AGENDA
CHASKA PLANNING COMMISSION
CHASKA CITY HALL - COUNCIL CHAMBERS & ZOOM
Wednesday, August 12, 2026
7:00 PM

REQUEST FOR ACTION CHASKA PLANNING COMMISSION 8/12/2026

Subject: Scandvik – Concept Plan

Synopsis: The applicant is requesting Concept Plan approval for an outdoor spa area at the Oak Ridge Hotel & Conference Center

Figure 9: Alternate Locations for Outdoor Spa

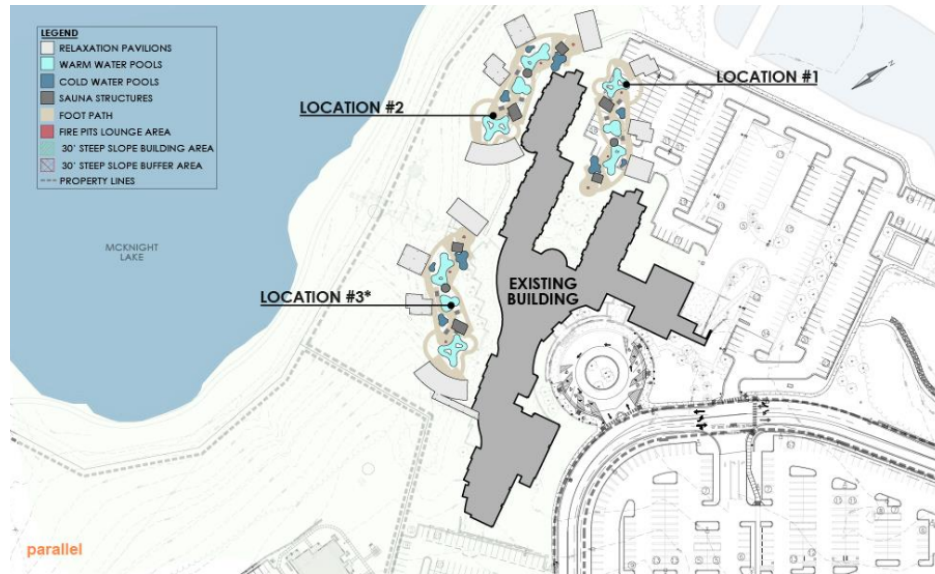
The applicant also looked at two alternate locations on site (Locations #1 & 2) – see *Figure 9*. Additional summaries of these alternates are included in the applicant's narrative. In short, **Location #2 also shows encroachment into the wooded steep slopes and setbacks and would not be supported by staff.**

Location #1 is the only alternate proposed that would not encroach into the wooded steep slopes and its setbacks. Location #1 impacts the parking expansion area needed to support the site. *Staff would be supportive of this location if a parking expansion alternative meeting parking requirements can be accommodated on site.*

- a. Concept Plan (pgs 1-33), prepared by Scandvik
2. Outdoor Spa Locations (#2 and #3) as shown on the Concept Plans, are not supported or approved by city staff due to impacts to the wooded steep slope and setbacks.

Figure 10: 2020 Aerial showing 'disturbance limits'

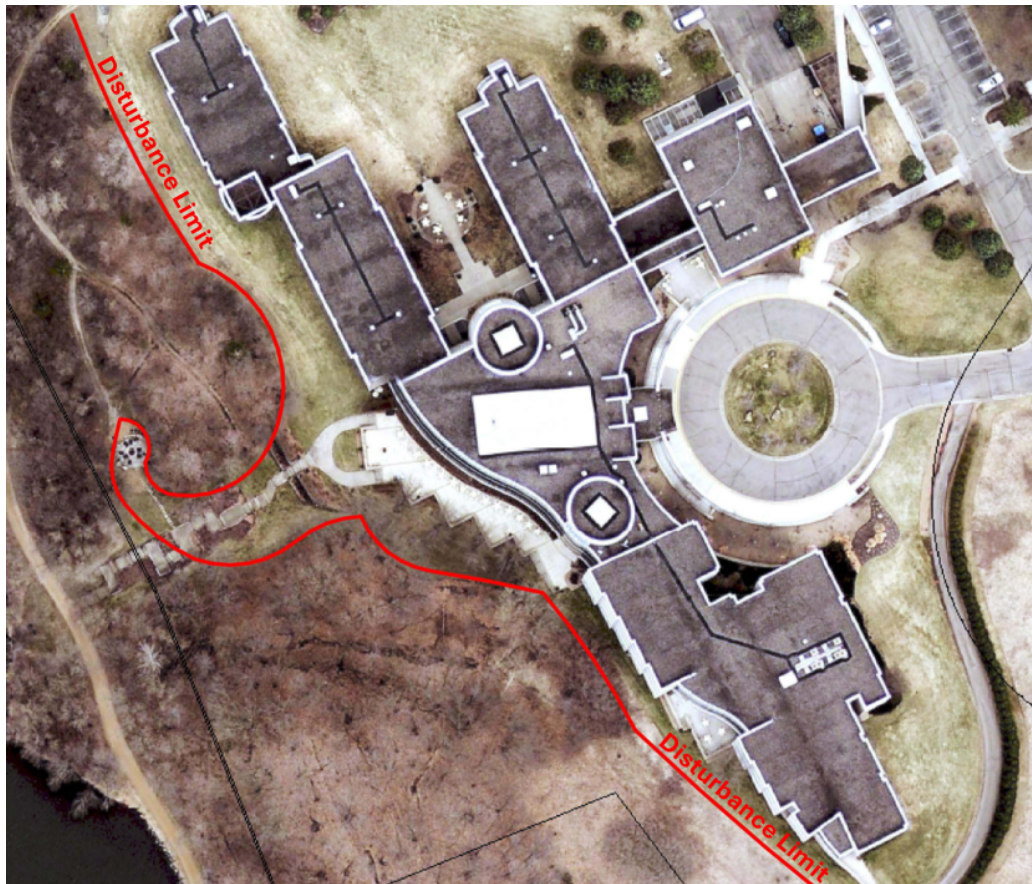
The 1987 approvals permitted the existing building and site to encroach into portions of the wooded steep slope setbacks, and what we are going to identify as its 'disturbance limits' – see *Figure 10*. The disturbance limits include portions of outdoor patios, mowed grass, pathways and a fire pit. Most of the disturbance limits stay outside of the wooded steep slopes except for the fire pit and pathway leading to the public trail. The disturbance limits have been actively maintained since the construction of the building, and since the building's closing in 2020 there has been some overgrowth, but the area is still generally intact.

- a. Variance Application, if required;
 - b. Zoning Ordinance Amendment Application, to include Outdoor Nordic Spa
 - c. Site Plan, showing exploration of the outdoor spa location within the 'Disturbance Limits' and no additional impacts to wooded steep slopes and its setbacks;

Figure 11: 2022 Approved Parking Plan

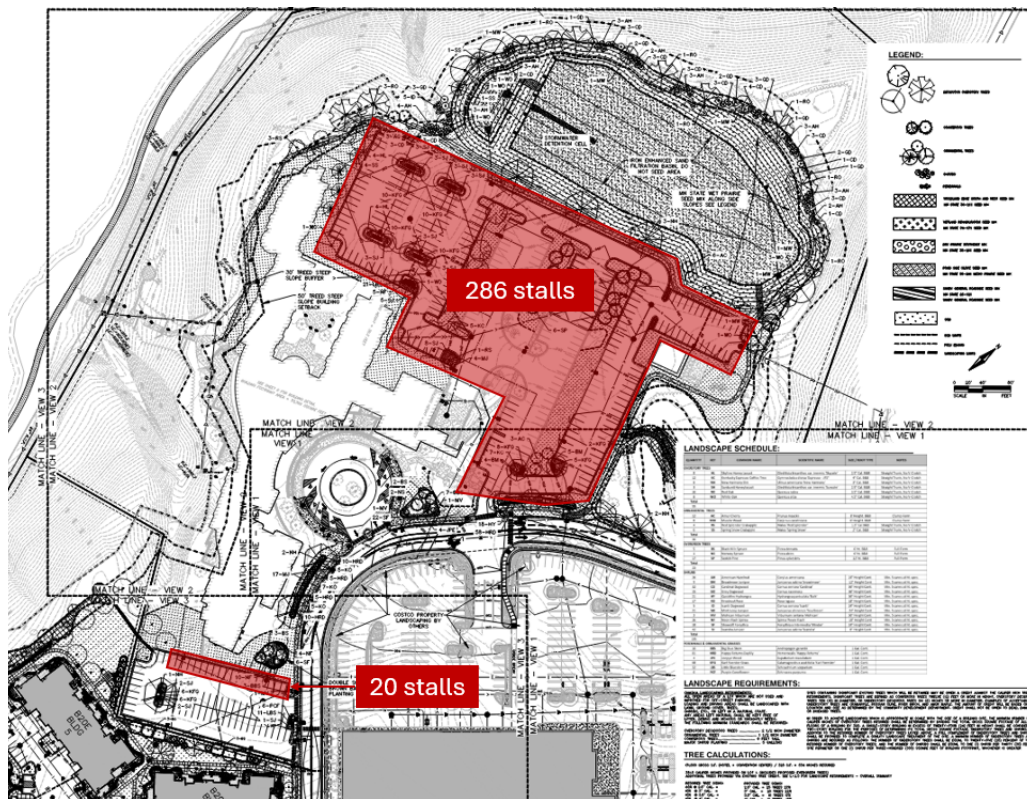
In the 2022 approvals, it was determined that the parking required for the existing hotel/conference center would be 294 parking stalls. The approved site plan showed incorporating 306 parking stalls on site; 286 parking stalls from a reconstructed parking lot north east of the building, and 20 parking stalls within the shared southern parking lot see *Figure 11*.

The proposed user intends to repurpose the existing building and add approximately 25,000 square feet of outdoor spa space. Based on the conceptual uses the below table is intended to summarize the parking requirements. *The applicant will also need to provide a parking analysis in their preliminary submittal to explain the parking needs for their proposed uses and how the site and parking plan can accommodate.*

- g. Stormwater Plan and Report meeting city and county requirements;
 - h. Grading Plan, including wooded steep slopes and its setbacks;
 - i. Parking Analysis, including a parking need summary and how the proposed parking plan is sufficient to meet needs and parking code;

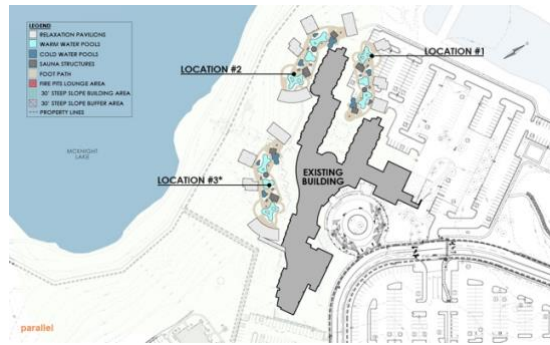
1. *More explanation of why the structured parking does not work financially and physically on site? What presume costs and/or physical detriments are known? What views, amenities, layouts (etc.), cannot be achieved in Location 1 that the preferred, Location 3 provides?*

2. *Show the proposed layout for Location 1.*
1. The cost of parking is prohibitive ranging between \$28,000 to \$35,000 per stall. It is anticipated that comprehensive design would require approximately 100 stalls to be placed in a structure, with a cost between \$2.8mm to \$3.5mm making the overall economically challenging, and therefore no longer attractive. While it is understood that “economic considerations alone shall not constitute practical difficulties” the financing of this project is highly complex with limited flexibility to increase the capital cost by a further 6% to 8%. Furthermore, the construction of a new structure would block the view from the entrance to the site which presently overlooks McKnight Lake.
